TO: David Ploense, Rick Engineering
FROM: Amber Wood Hicken, Planner I
DATE: 7/24/25
SUBJECT: Douglas 234 Dunkin Donuts, Site Plan
Review Comments 05

**SITE PLAN FOR
DUNKIN' DONUTS
DOUGLAS 234, FILING NO. 6,
AMENDMENT 1, LOT 4**

LANDSCAPE PLAN & DETAILS

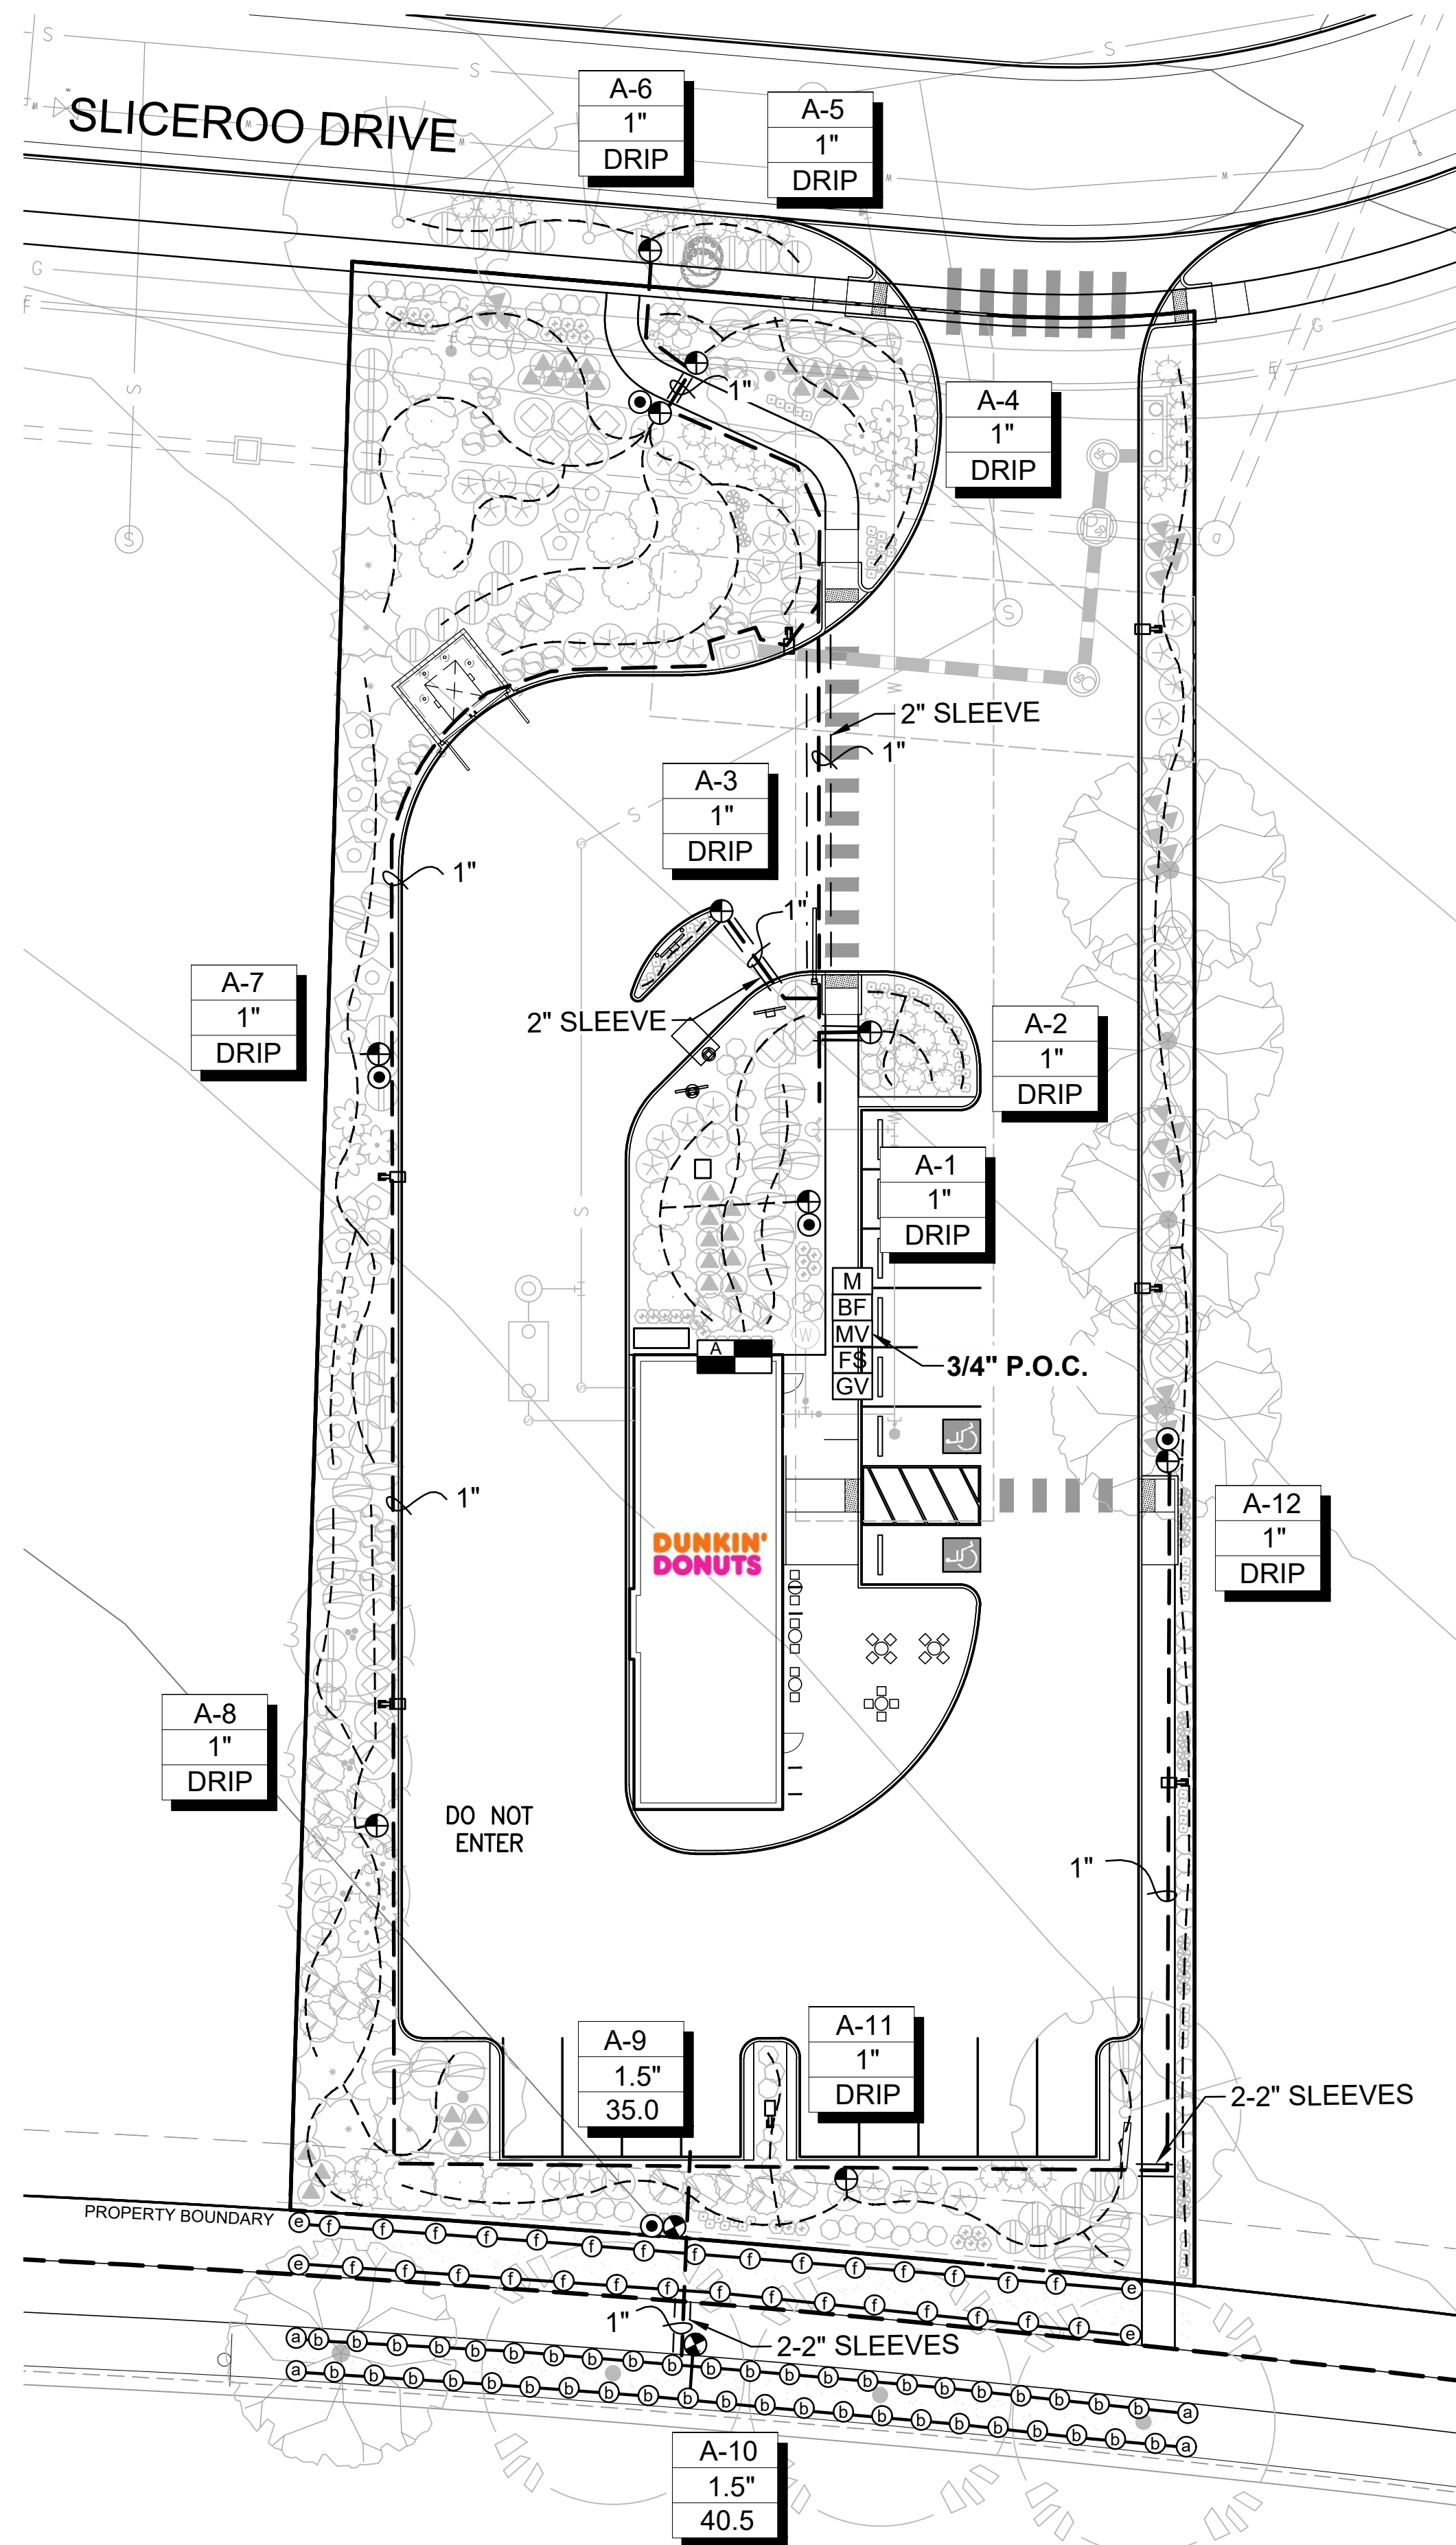
streetscape design was approved as part of original plat - revert to original design to avoid triggering a site plan adjustment to those plans.

a site plan adjustment can be submitted for in the future to change out the turf.
